Revision information for E10M_nnn.exe firmware

A5.04[2014-Dec-11] by Martin

For example:

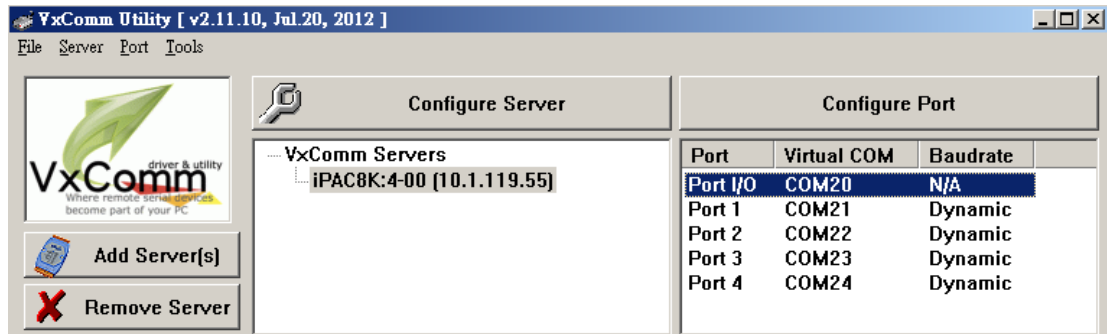
In DCON firmware version 504 or later version, users can set i-8431/i-8831 COM1/ COM3/COM4 as uplink Port or Vxcomm Port. When COM Port set as Vxcomm Port, use can configure remote I/O modules on this i-8431/i-8831 COM Port. When COM Port set as uplink Port, user can configure backplane I/O modules via i-8431/i-8831 COM1//COM3/COM4. And it support multi-users to configure backplane I/O modules in the same time; In previous DCON firmware, i-8431/i-8831COM3/COM4 only can be as Vxcomm COM Port.

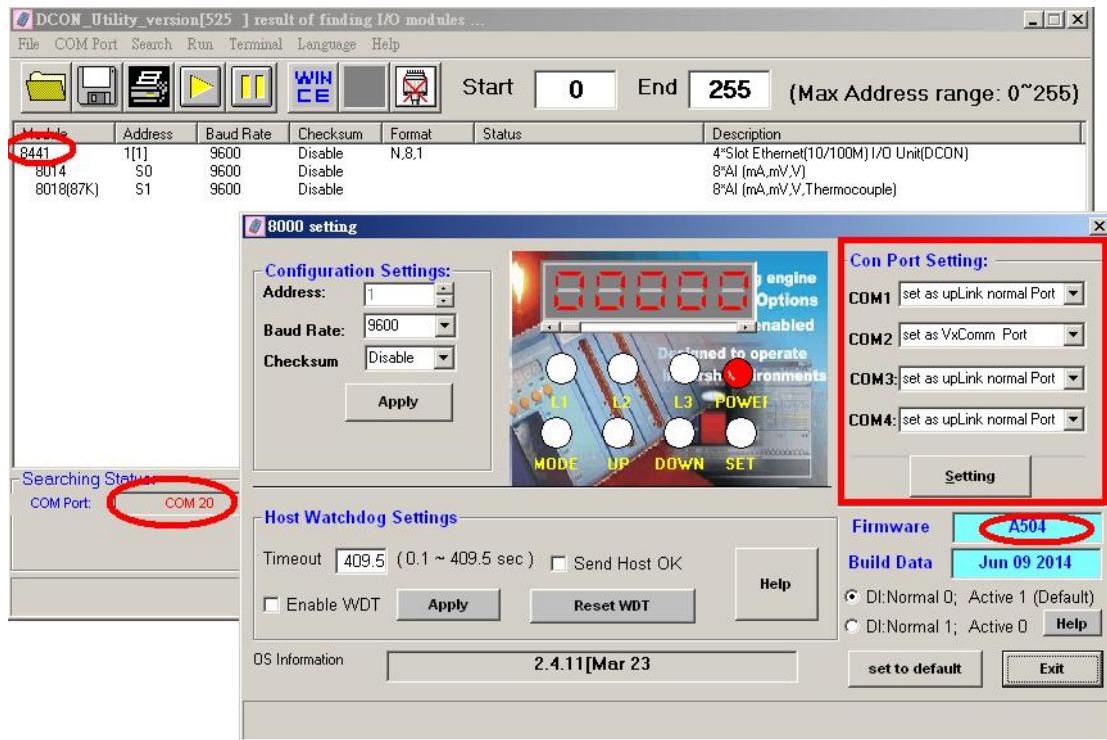
We can use Vxcomm Utility to map Virtual COM Port for all COM Port as below:

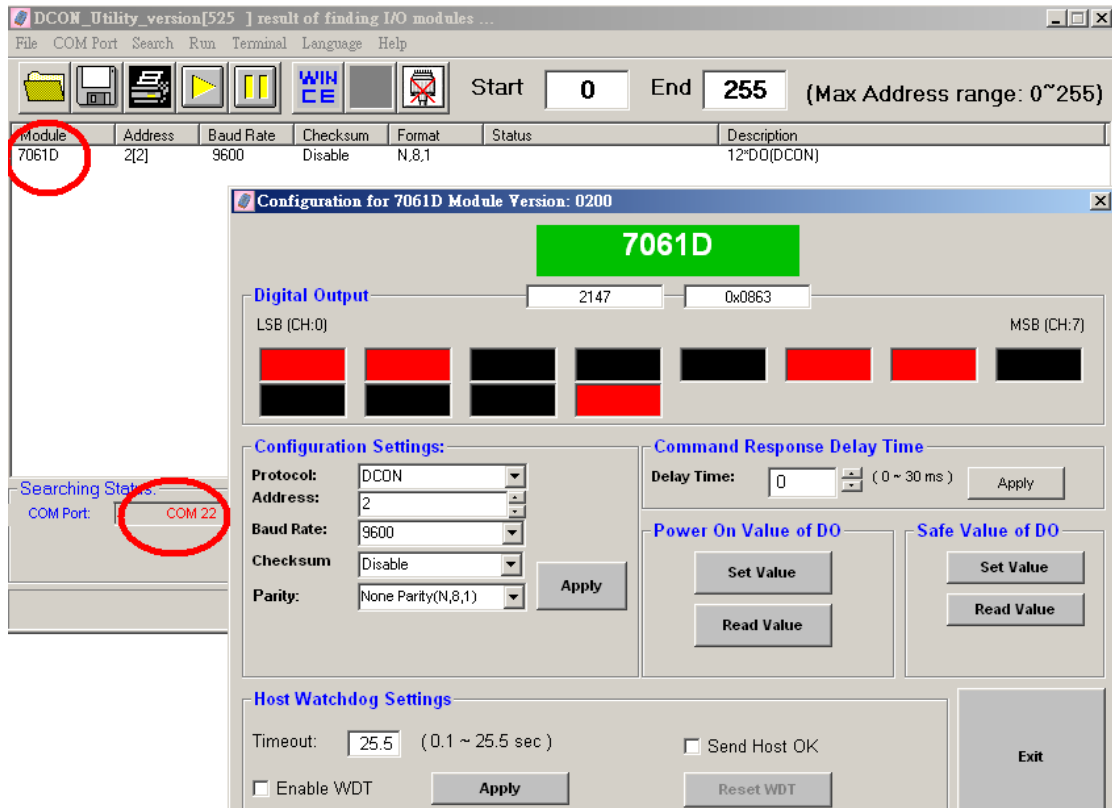
We can set some of COM for uplink Port and some for Vxcomm Port from COM20 as below:

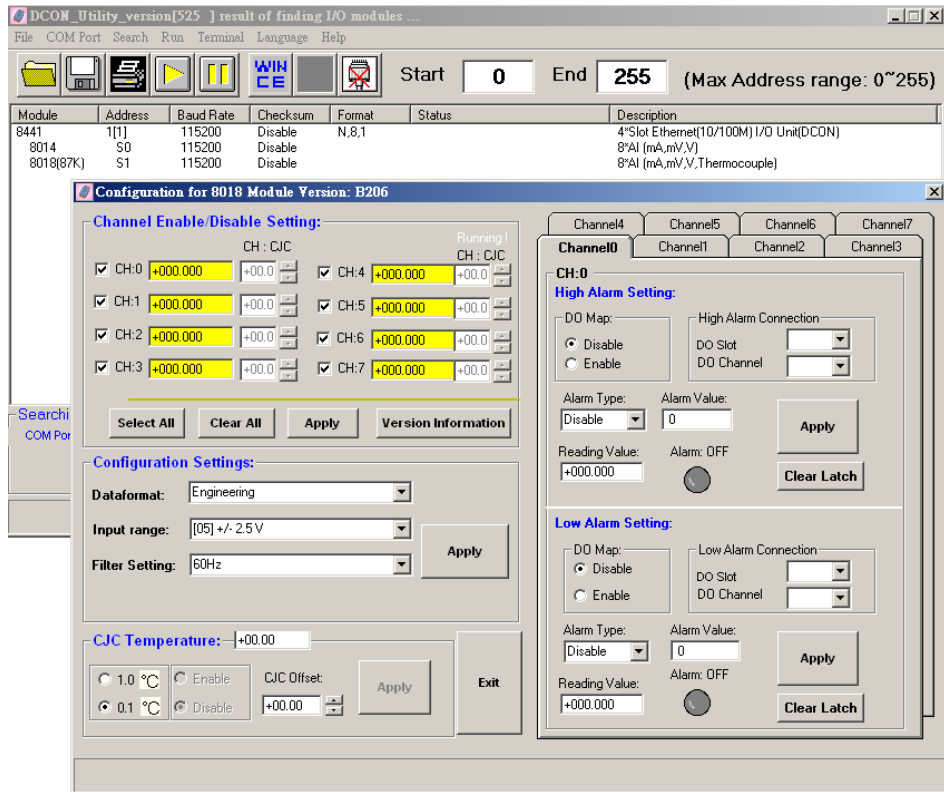
Host PC 1 can configure I-7061D on iP-8441 COM2 via Virtual COM Port 22:

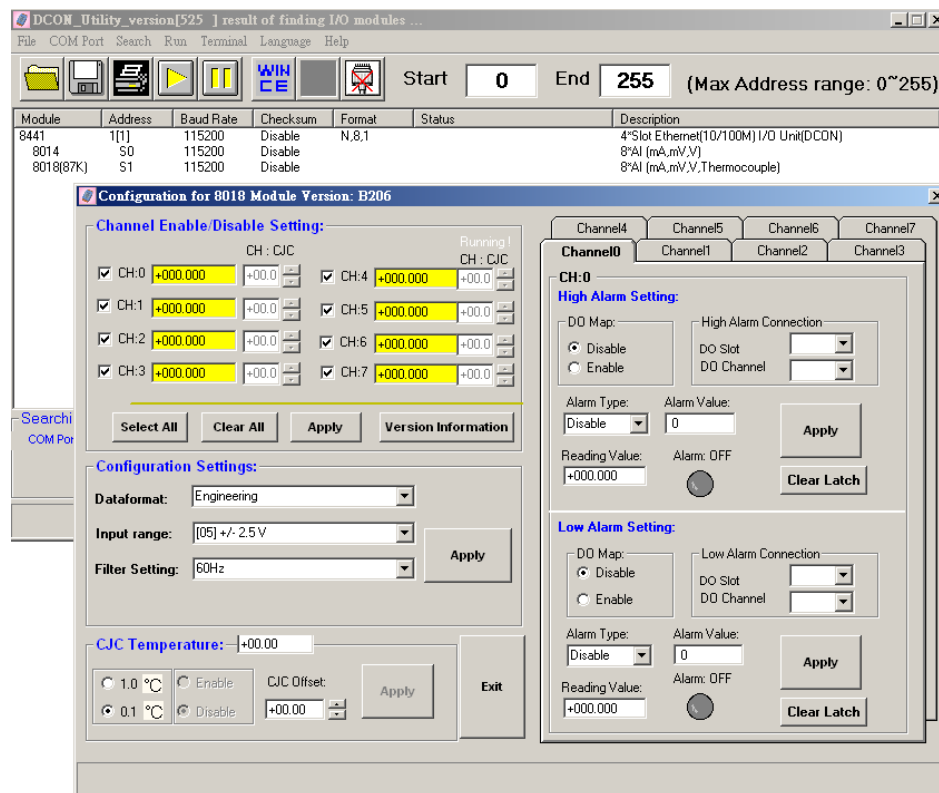
Host PC 3 can configure backplane I/O module via iP-8441 COM3
